**SUBJECT: CLASS 3 DESIGN REVIEW, CLASS 3 SITE PLAN REVIEW, SOUTH
WATERFRONT MIXED-USE ZONE DEVELOPMENT PHASING PLAN
MODIFICATION, CLASS 2 ADJUSTMENT, AND CLASS 2 DRIVEWAY
APPROACH PERMIT CASE NO. DR-SPR-SWMUDPP-ADJ-DAP21-01; FOR
PROPERTY LOCATED AT 295 COMMERCIAL STREET SE
(AMANDA APPLICATION NOS. 20-113053-DR; 20-113054-RP; 20-114117-
ZO; 20-113056-ZO; & 20-113057-ZO)**

A consolidated application for a proposed new four-story mixed-use building consisting of a 72-bed post-acute rehabilitation facility and approximately 3,940 square feet of ground floor commercial space. The application includes the following:

The subject property is approximately 1.14 acres in size, zoned SWMU (South Waterfront Mixed-Use) and located at 295 Commercial Street SE (Marion County Assessor Map and Tax Lot Number: 073W27BA03100).

1 PLANTING PLAN

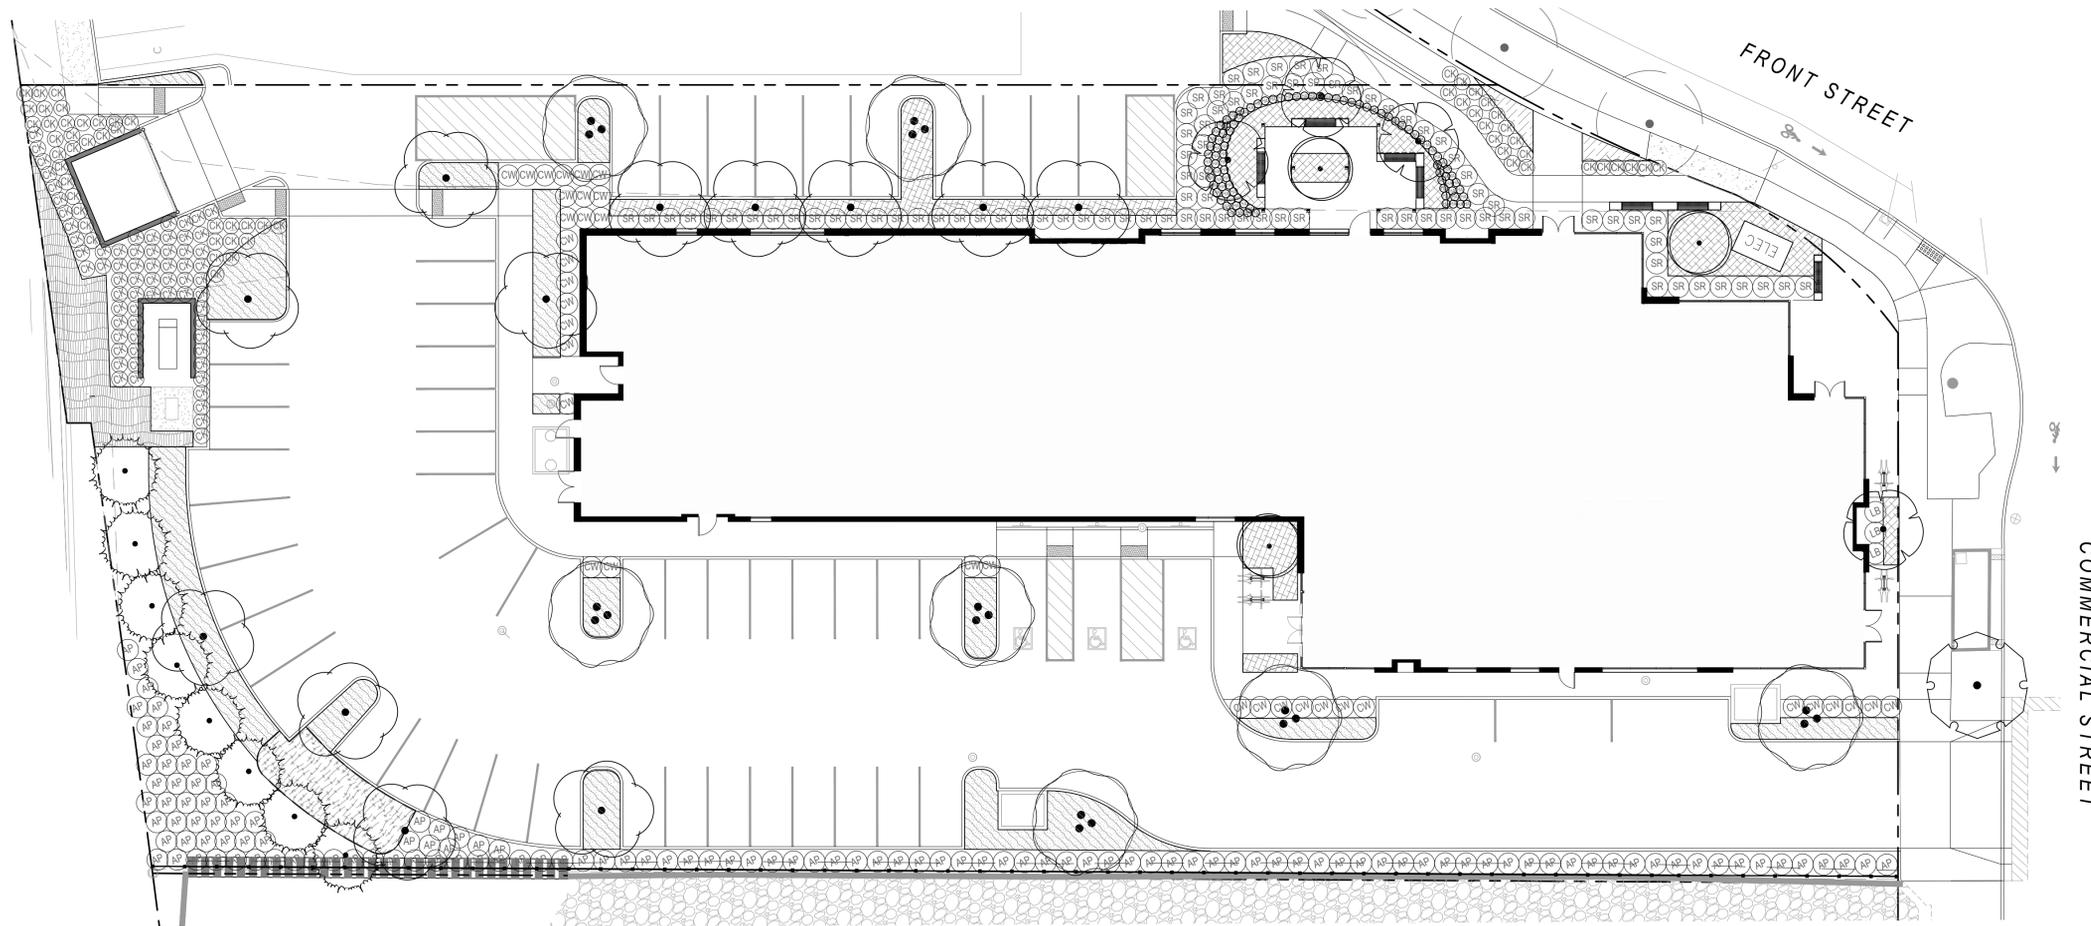
existing retaining wall and the applicant's development site. A landscape bed planted primarily with shrubs and a few trees (where spacing allows), is proposed along the south property line. The landscape design indicates that the shrub planting will use *Arctostaphylos patula* / Green-leaf manzanita, a shrub that averages between 3 to 6 feet in height, which will screen the vehicle use areas from the future pedestrian path. The existing conditions, topography and proposed landscaping will provide the "well-defined building wall edge along the north bank of the creek" that the guideline is seeking.

In order to buffer the proposed driveway and parking area located on the south side of the property from the creek corridor and to create a well-framed open space environment along the creek, a combination of landscaping and trees, where space allows, is provided. As shown on the landscape plan and indicated in the applicant's written statement, the proposed shrubs provided along the southern property line include Greenleaf Manzanita that grow three feet to six feet in height. Because Greenleaf Manzanita produce fruits/berries that can pose a potential long-term maintenance issue for the future abutting pedestrian path to the south, an alternative sight-obscuring shrub will need to be planted along the southern property line to buffer the proposed driveway and parking area from the creek while not creating a potential maintenance issue. As such, the following condition or approval is recommended.

Condition 1: The landscaping plan shall be revised to replace the Greenleaf Manzanita proposed along the southern property line with an alternative sight-obscuring evergreen shrub, or variety of evergreen shrubs, that will grow to a height of 3 feet to 6 feet and not produce fruits/berries.

WEST ELEVATION
SCALE: 3/32" = 1'-0"

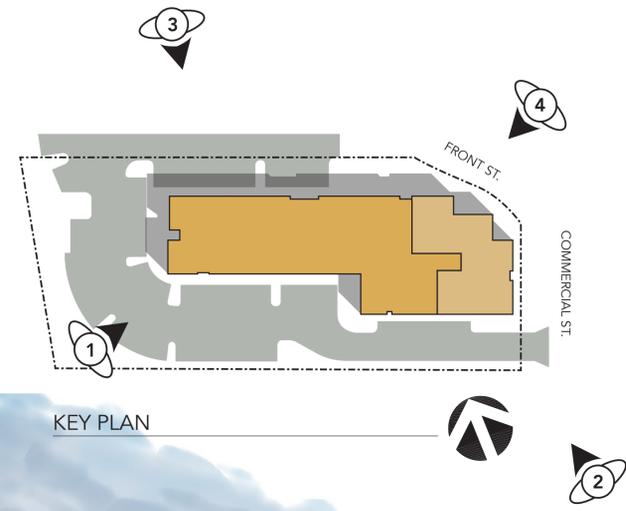
The written statement provided by the applicant (**Attachment F**) indicates that the development site contains a gateway at the site’s northeast corner where Commercial street and Front Street intersect. The building design incorporates “tower” block elements to break up mass and horizontal planes. These tower blocks highlight the site’s gateway corner and street presence through the use of contrasting color, façade materials and architectural details especially for those portions of the building that contain retail commercial uses on the ground floor. A plaza and landscaping is located at this corner promoting interaction between the public right-of-way and the development highlighting the ground floor tenant spaces, therefore meeting guidelines (aa) and (cc) as needed.

Condition 2: The design of the building adjacent to the corner of Commercial Street SE and Front Street SE shall be revised to incorporate additional architectural detailing, such as a projecting roof, increased building height or massing, or special window treatments, to visually emphasize the corner of the building.
